35/13-980 14 Hesketh Street
(Chevy Chase Village Historic Dist.)

RENOVATION OF THE
CHAPMAN-CUSHING RESIDENCE
 14 HESKETH STREET
 CHEVY CHASE, MARYLAND 20815

APPLICATION FOR
HISTORIC AREA WORK PERMIT

HISTORIC PRESERVATION COMMISSION STAFF REPORT

GLAZING OPTIONS

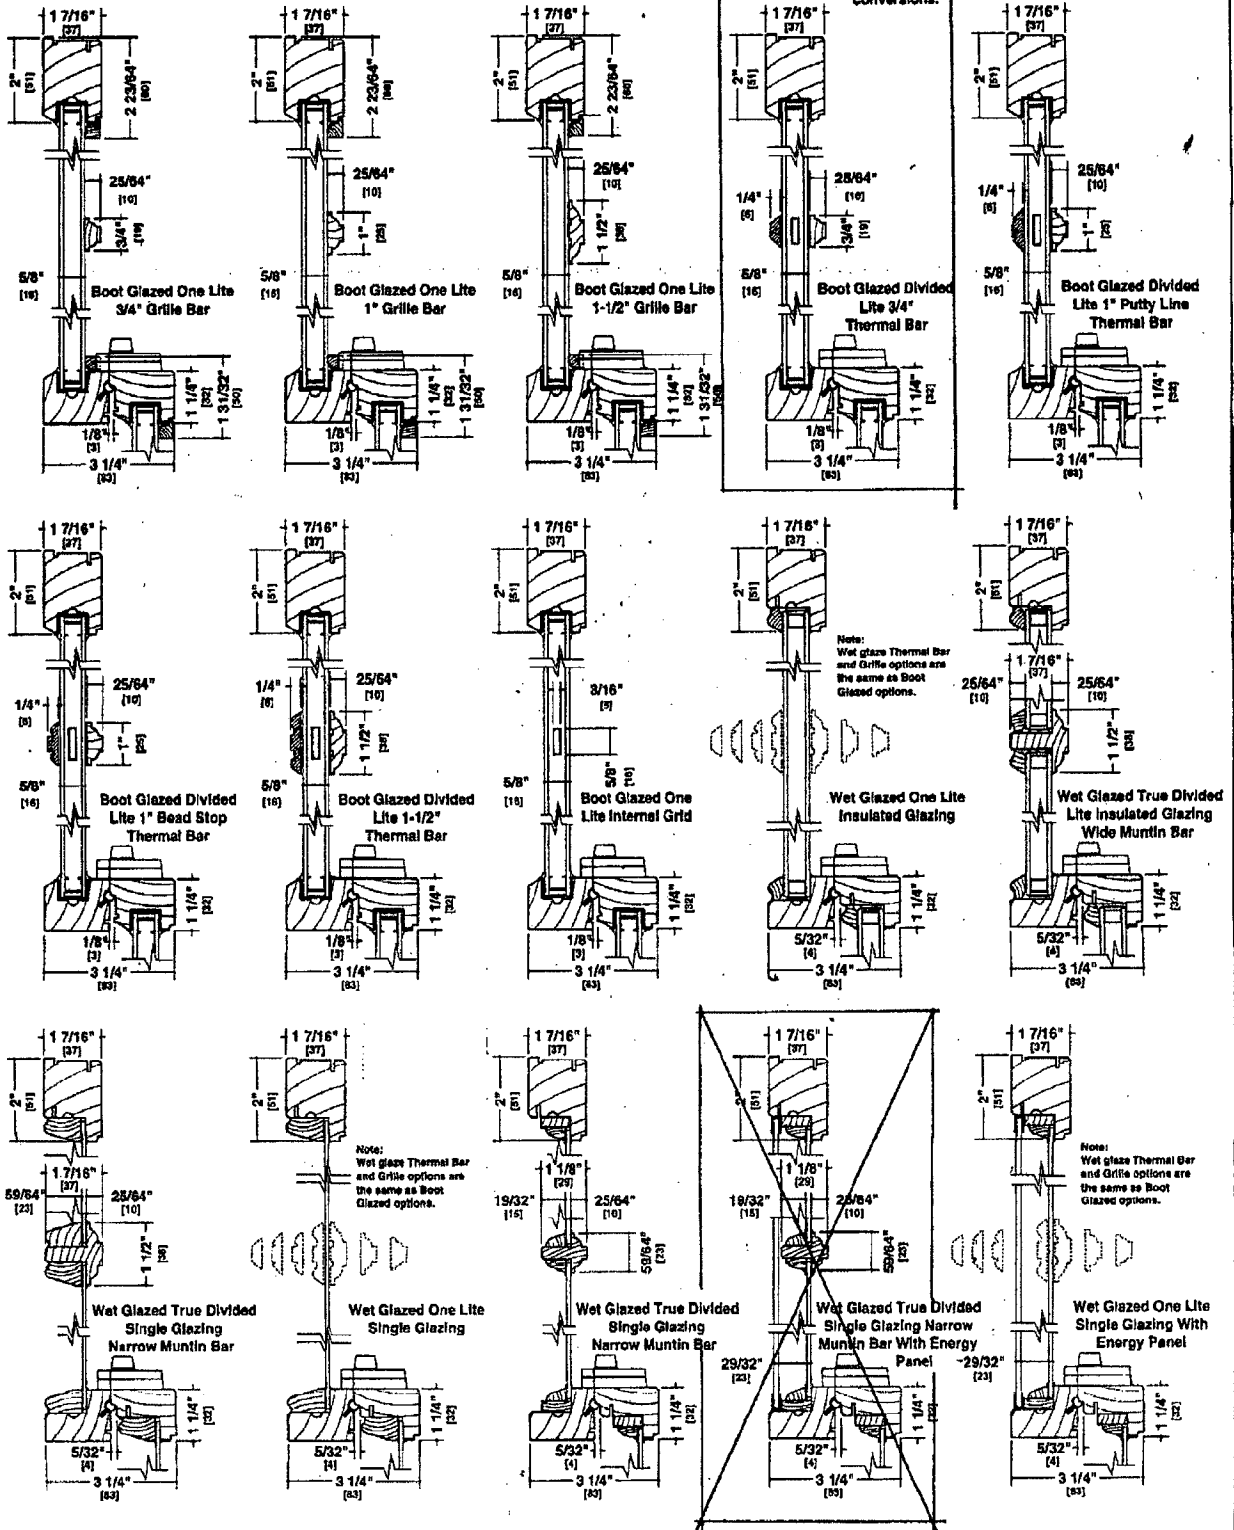
Per your suggestion, Muse Architects is prepared to change the specification for new windows for the above referenced project to Pozzi boot glazed simulated divided lites (insulated glass) with a 3/4" muntin profile, rather than the true divided lite window with a 59/64" muntin bar as previously specified.

NORTH ELEVATION
SCALE 1/4" = 1'-0"

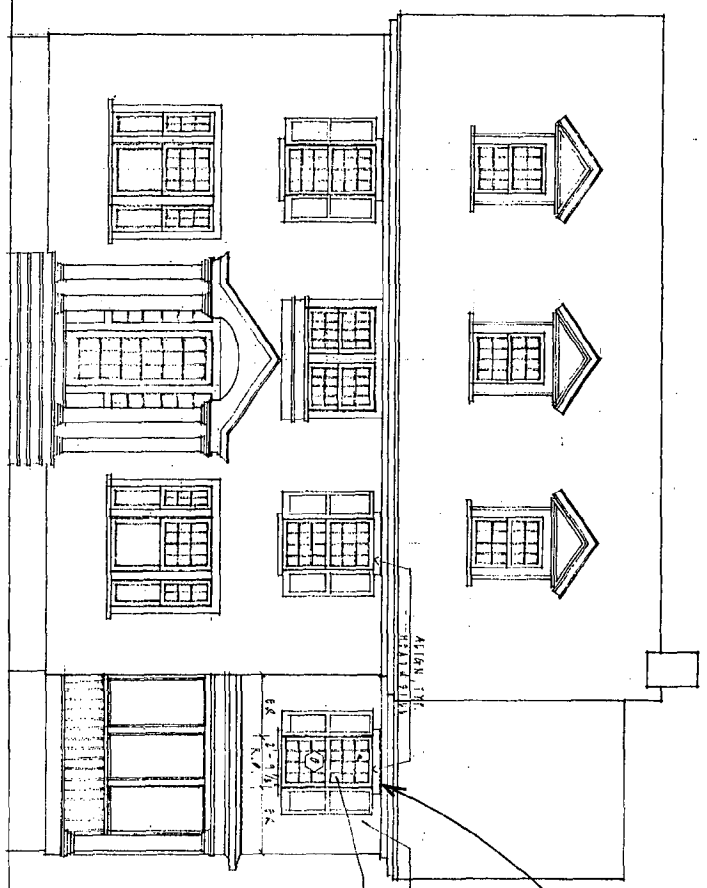
Front (North) elevation: The small triplet windows on the second floor on the west addition would be removed and replaced with an existing window from the West elevation (see Circle 16 & 17). The proposed new window would be set to match the head height of the existing front facade windows. The applicant would achieve additional wall space to build interior closets on either side of the new opening.

The applicant proposes some alterations of a Contributing Resource in the Historic District. The greatest concern is with the front elevation. Staff notes that the windows proposed for removal are non-original and represent an earlier alteration to the original structure. The proposed reuse of the existing window (which is proposed for removal from the west elevation) will mean that the window profiles will match (or be a good match) along the front elevation.

WEST ELEVATION - EXISTING

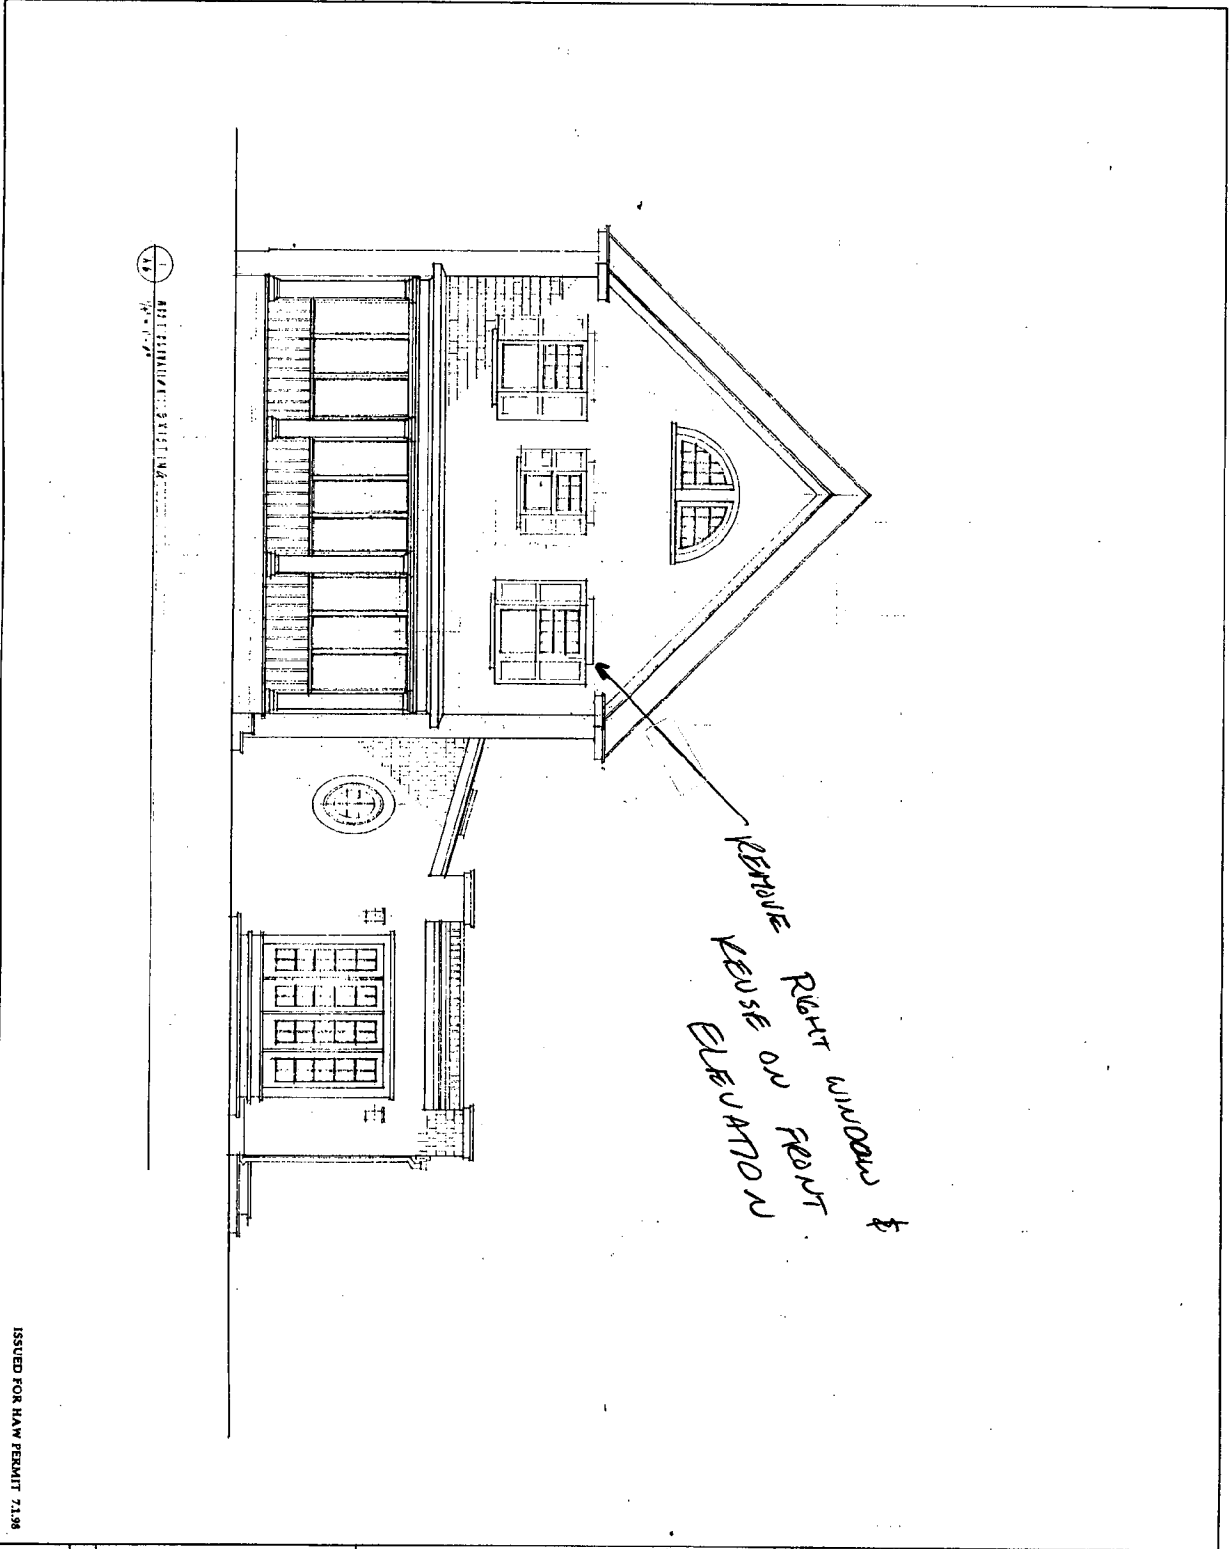
Side (West) Elevation: The window towards the rear on the on the second floor would be removed, and reused on the front elevation. The right side window would be replaced with a triplet series of

WEST ELEVATION - PROPOSED

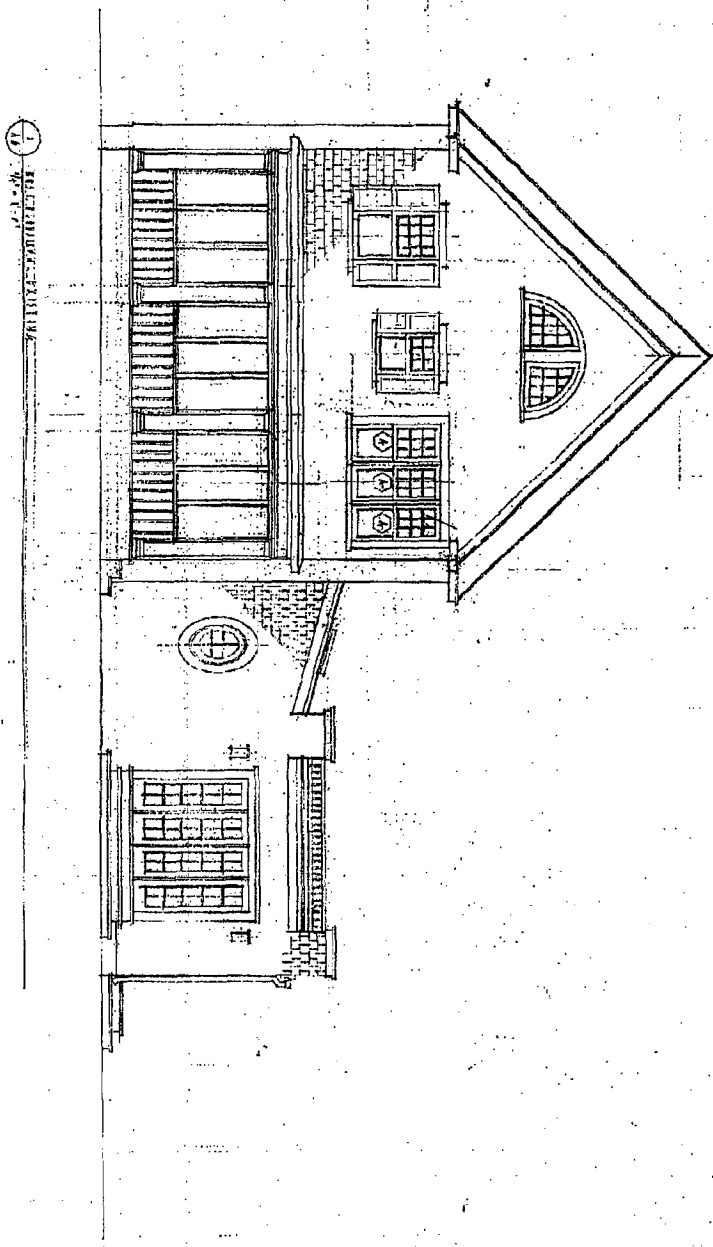
windows glazed as 9/1 to be compatible with the existing fenestration pattern. The applicant would achieve additional wall space for the closet, and additional light for the Sitting Room. (See Circle 18,19)

The proposed replacement of the single windows on both the west and south elevations don't really achieve much for the exterior of the house in terms of the disruption of the existing symmetry. However, the use of the triplet windows towards the rear of the side facade will reduce their visibility, and overall impact from the public right-of-way. The proposed use of the triplet windows on the south facade will maintain the hierarchy of an element (side porch) secondary to the main block of the house.

SOUTH ELEVATION

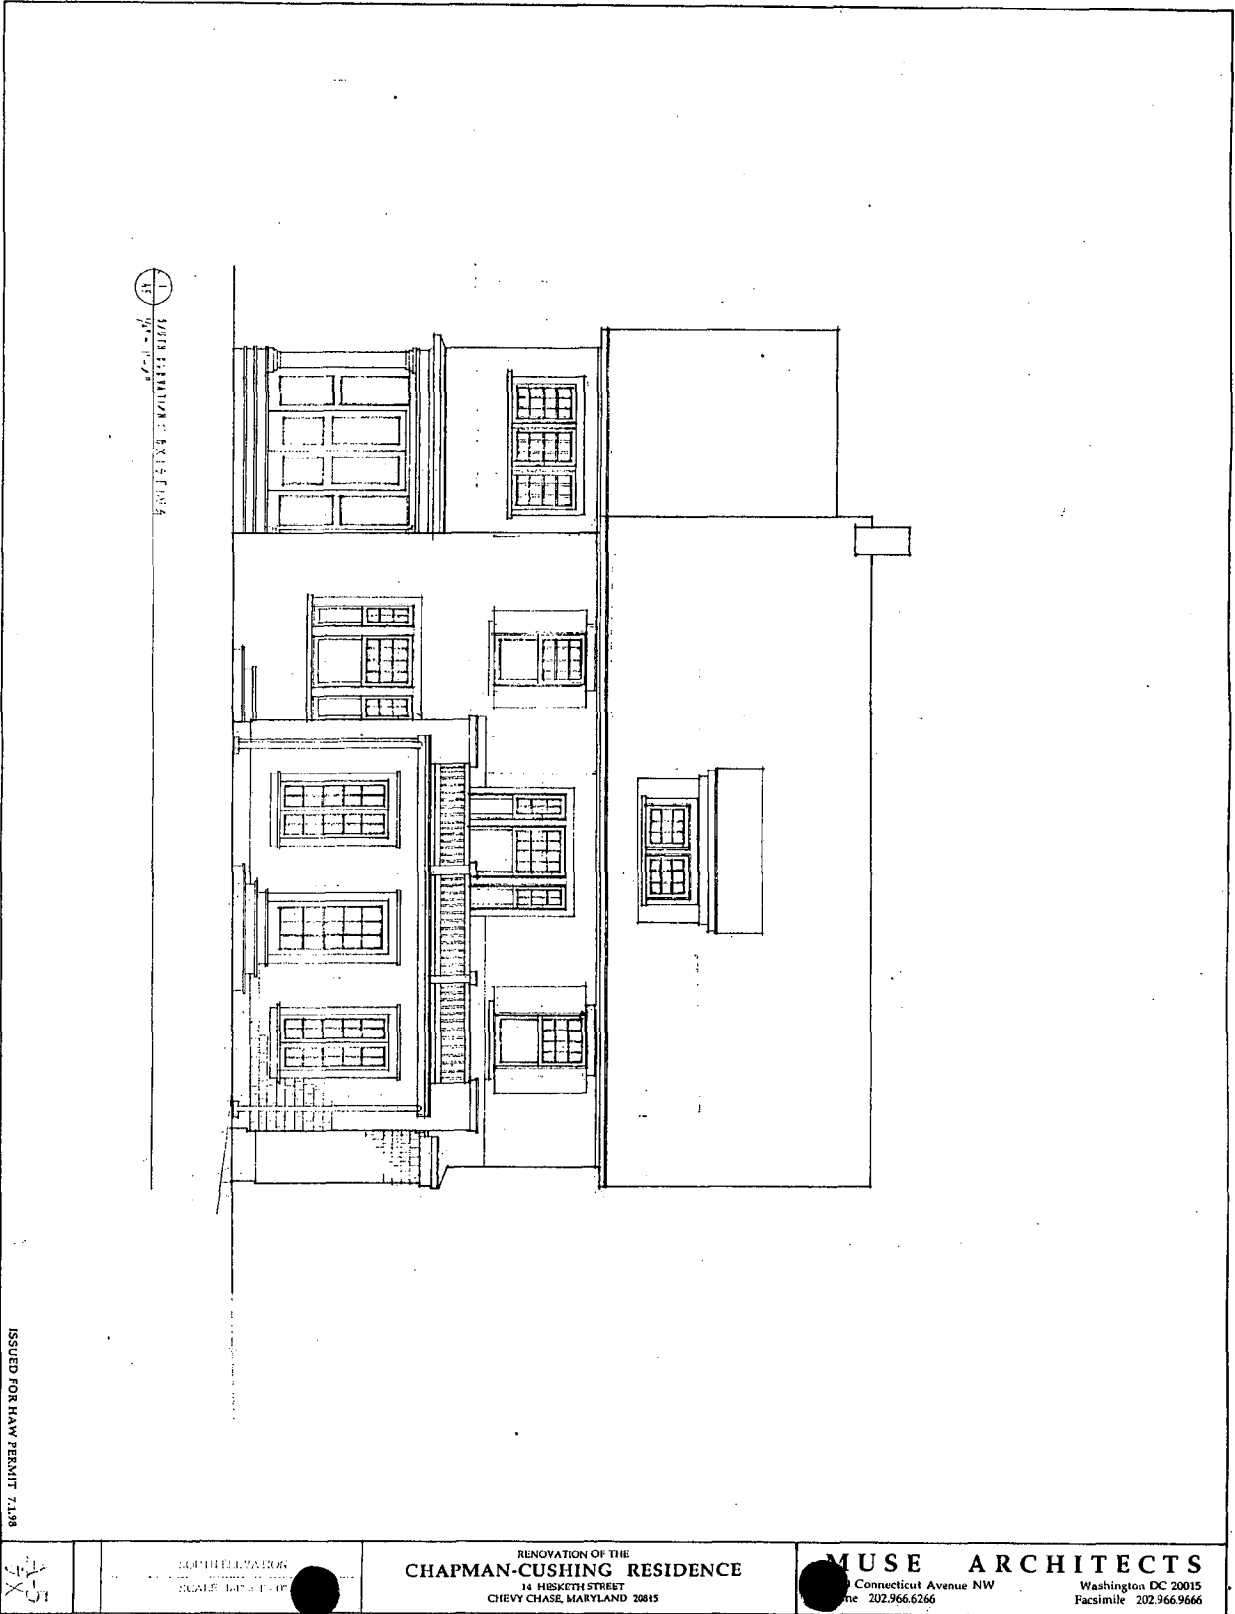
Rear (South) Elevation: The triplet casement windows in the rear second-story porch would be replaced with new double-hung windows to match the new windows on the west elevation. The windows in the Sitting Room will then be a matching set (see Circle 20).

The rear left window at the second floor level will be removed, and the siding patched in to match the existing siding. Two new windows will be placed which effectively sit at the edges of the room, providing additional centralized interior wall space in the bedroom area (see Circle 20,21).

A small skylight will be added in the bedroom on the rear roof (see Circle 21).

The proposed removal of the window on the rear elevation and the replacement with the two side-set windows, makes less sense from the exterior than it does from the interior. However, changes at the rear which are not visible from the public right-of-way are approvable, as per the Chevy Chase guidelines in the Amendment. In the same vein, the proposed skylight at the rear will not be visible from the public right-of-way.
